Figure 2.12b
Infrastructure Design Review
- Turbine 02

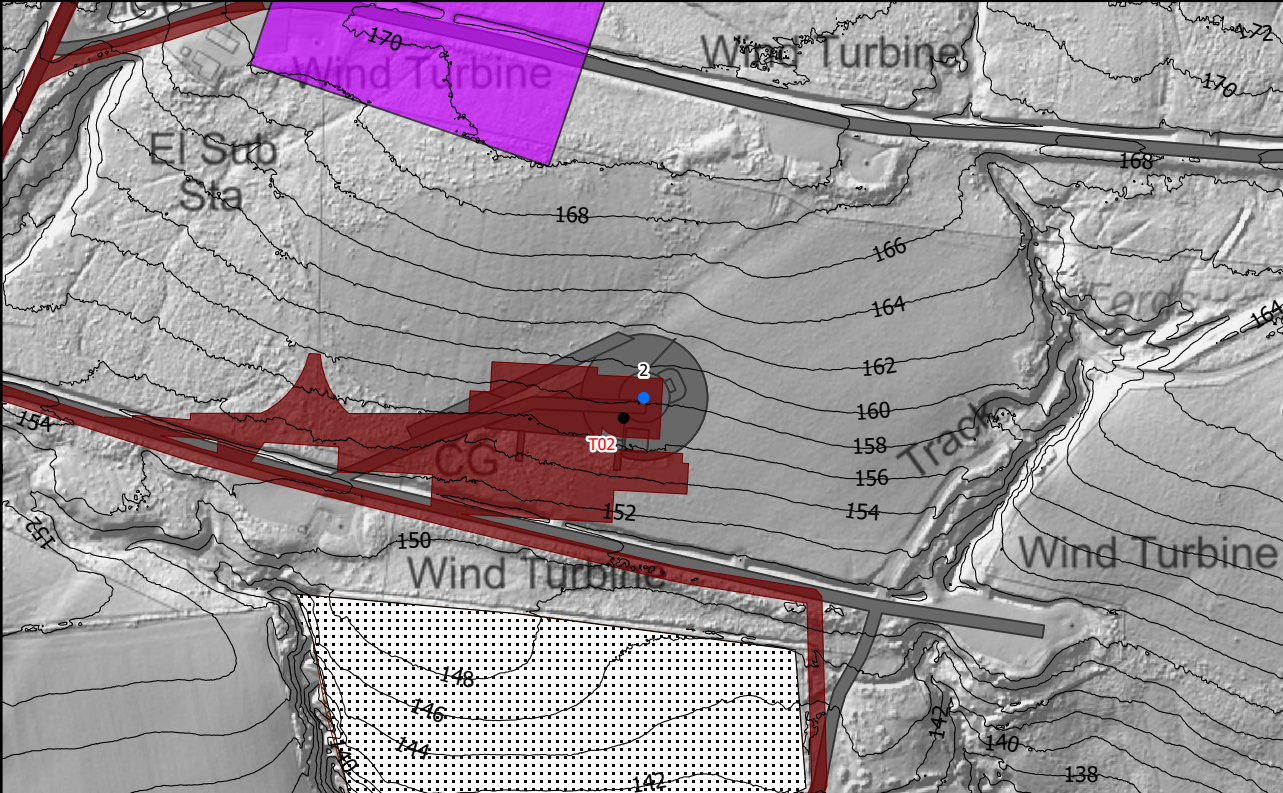
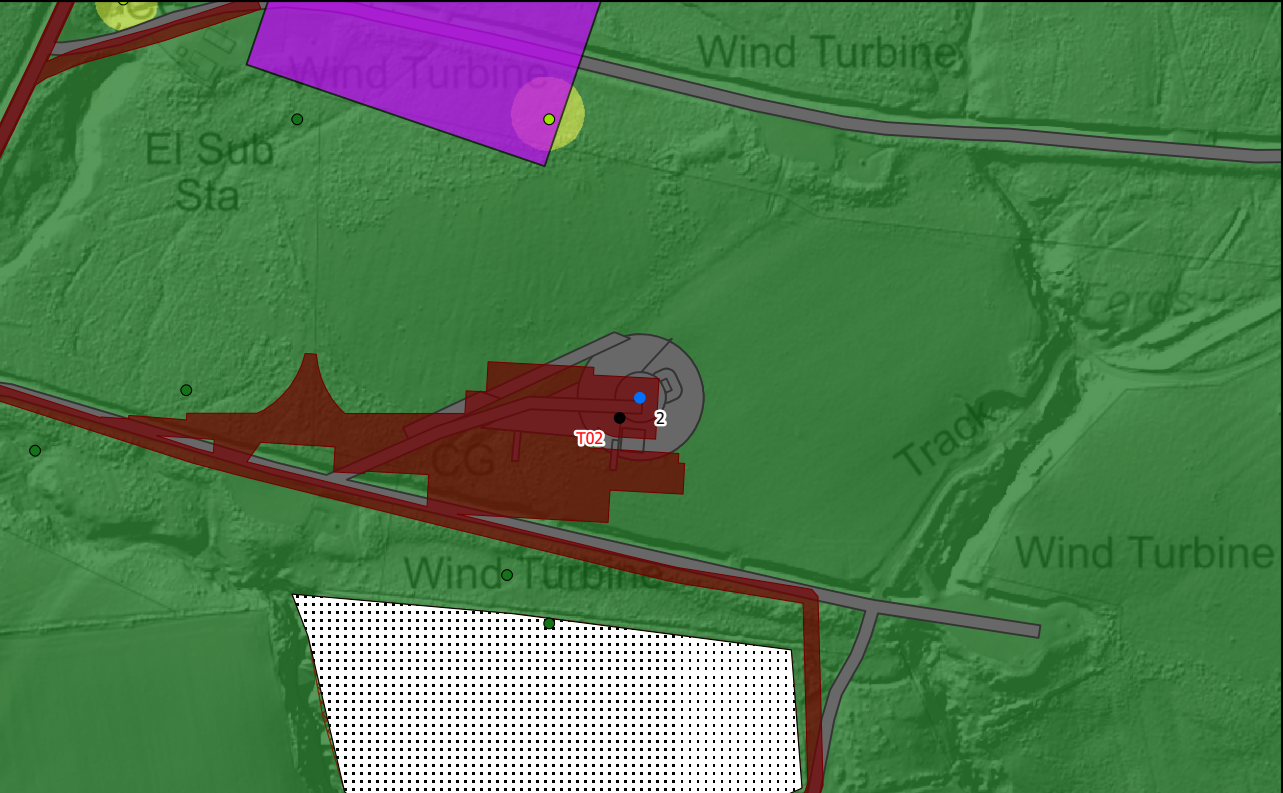
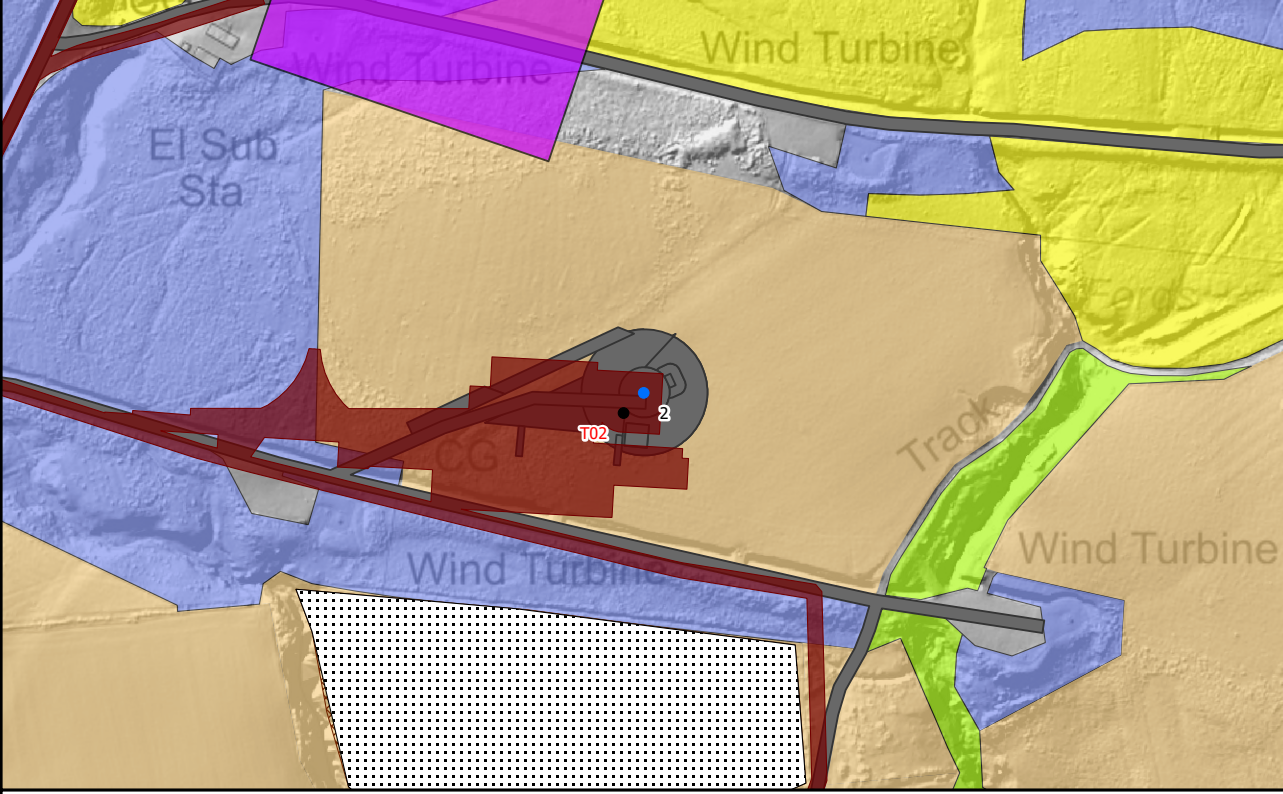
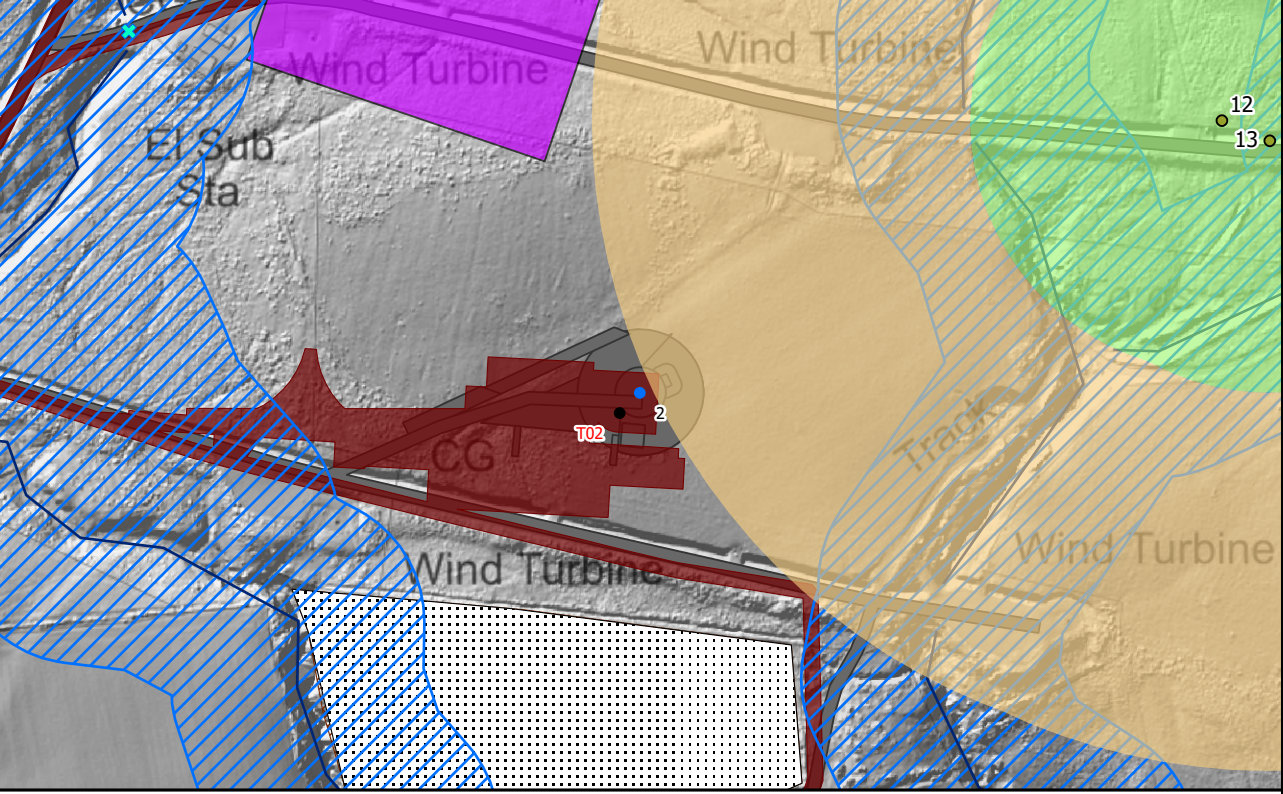
T02: Reason for Moving: The move was necessary to ensure that suitable separation distances were maintained between turbines. Where possible a minimum of three times the rotor diameter is required between turbines. The move is relatively small compared with the consented layout at a distance less than the 50m micrositing limit from the current consented location.

Engineering: The orientation of the hardstand has been positioned to follow the contours of the land as much as possible to reduce the required cut and fill during construction. The entry to the spur aligns with the existing spur of Tangy I/II. This track will need to be upgraded as part of the new development. The plan for turbine component deliveries is to drive directly onto the hardstand in a forward direction. A small unloaded turning head will be integrated into the hardstand features to allow for delivery vehicles to turn and leave the site. The distance back to the main windfarm spine road is further than what would be acceptable to the delivery companies, therefore the turning head is a necessary feature for this location.

Geology Impacts: The larger hardstand required the platform to be rotated clockwise. All proposed infrastructure within current consented 50m micrositing buffers. All proposed infrastructure in similar shallow peat depths. The unloaded turning head is located in an area of very shallow to zero peat.

Ecology Impacts: The new location for the infrastructure sits within the same NVC areas as the consented development. The track length to the turbine remains similar to that of the consented layout. The infrastructure will be located in predominantly MG7, Mire with the spur crossing existing wind farm track and some M23 Mire. This is inline with the consented layout, albeit with an increased footprint.

Hydrology Impacts: The platform and the majority of the ancillary features are positioned outside of the 50m water course buffers. The infrastructure within the water course buffer builds on existing track and water course crossings that are used on the operational Tangy I/II windfarm. The turbine has been positioned to be outside of the Private Water Supply (PWS) 13 and 12, however works (including excavation) for hardstand is within 250m risk buffer. PWS 12 is no longer in use and fed the existing wind farm. PWS 13 is in use and feeds the properties to the south of the windfarm.
